SERVICE INSTRUCTION **SI0040** Rev NC **Page 1 of 6**

SUBJECT: *REPLACEMENT OF WIG-WAG FLASHER SP74005-001, SC73107-001, AND ALL SC73106 PRIOR TO REVISION D.*

MODELS AFFECTED: *CC11-100 AND CC11-160 SN 00107 to 00441
CCK/CCX-1865 PRIOR TO 0039
CCK/CCX-2000 PRIOR TO 0179*

Figure 1: Behind Instrument Panel - First Gen Flasher

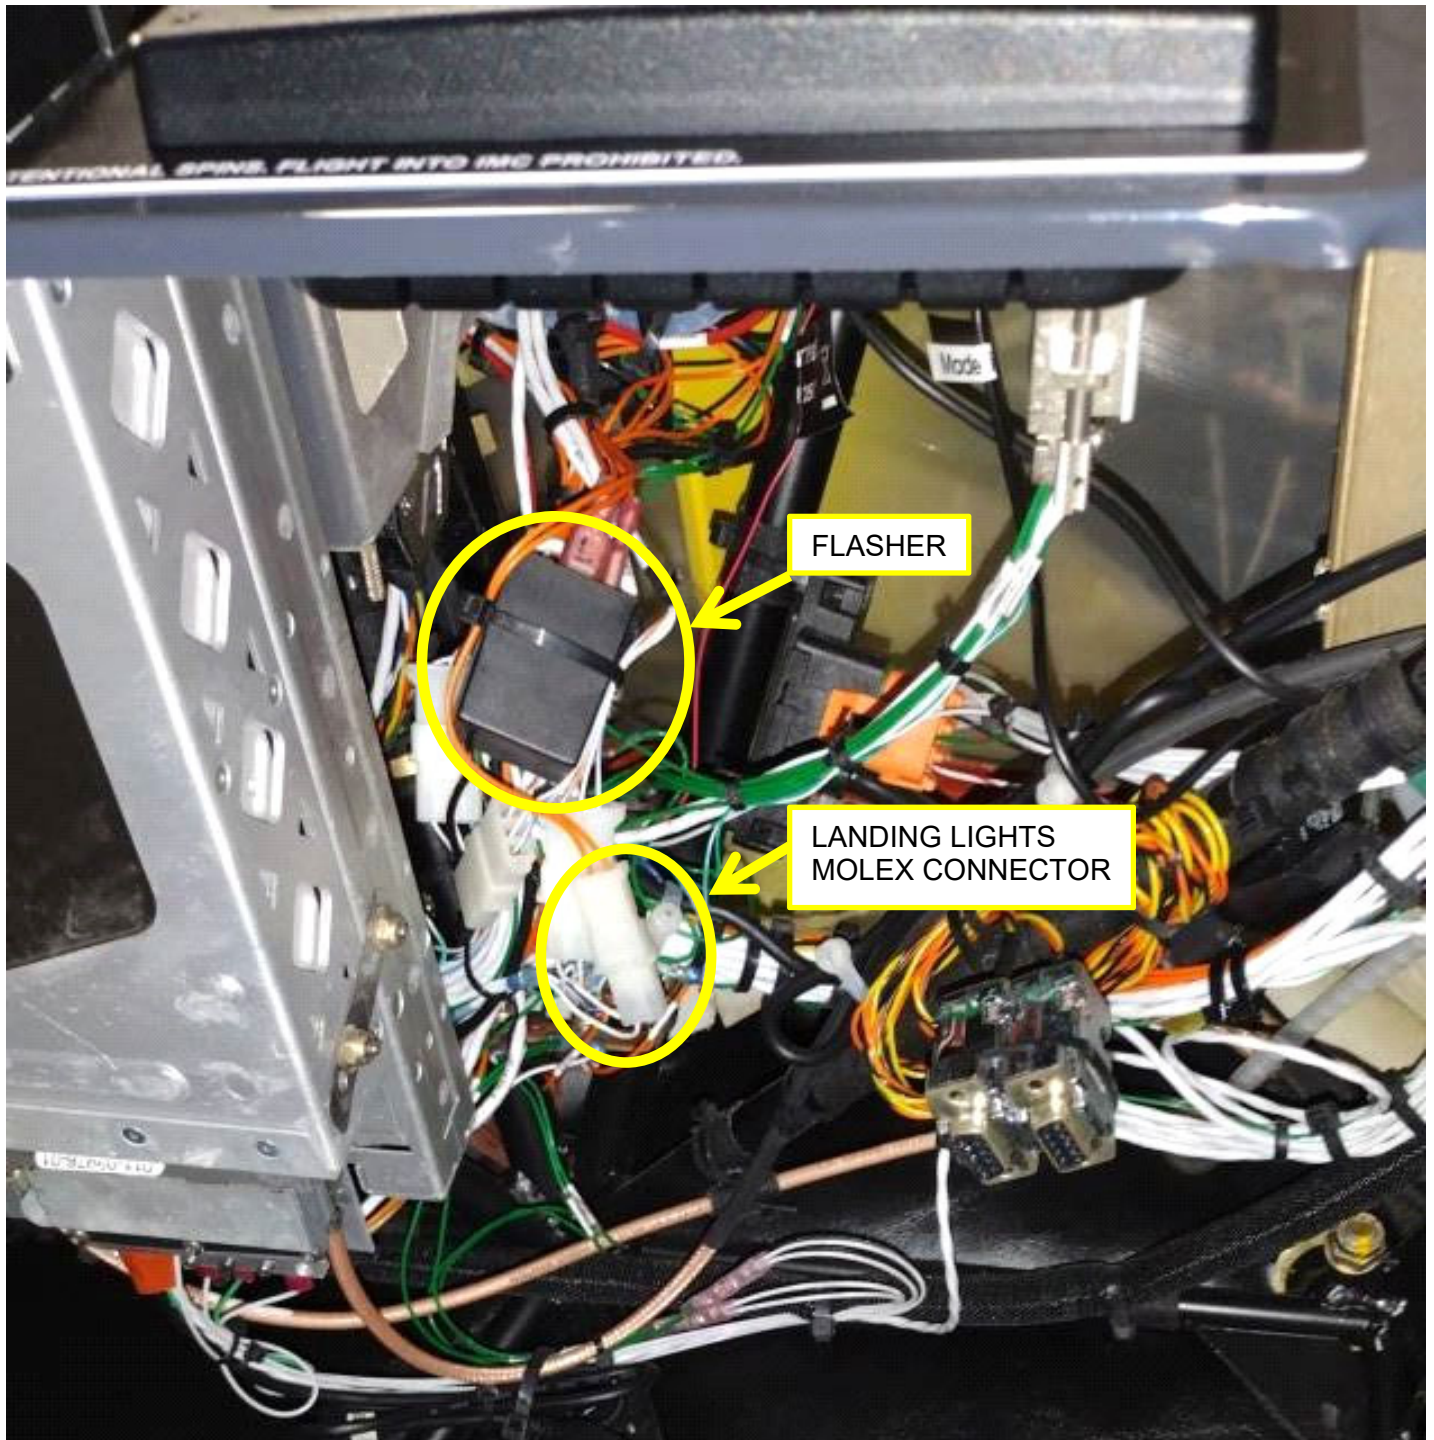
1. Read all instructions before beginning any work.
2. All work will be accomplished behind the instrument panel.
3. Locate landing light switch and unbundle the wires and flasher devices between the switch and the 2-pin molex connector to wires LB01A20W-1 and LB14A20W-1.
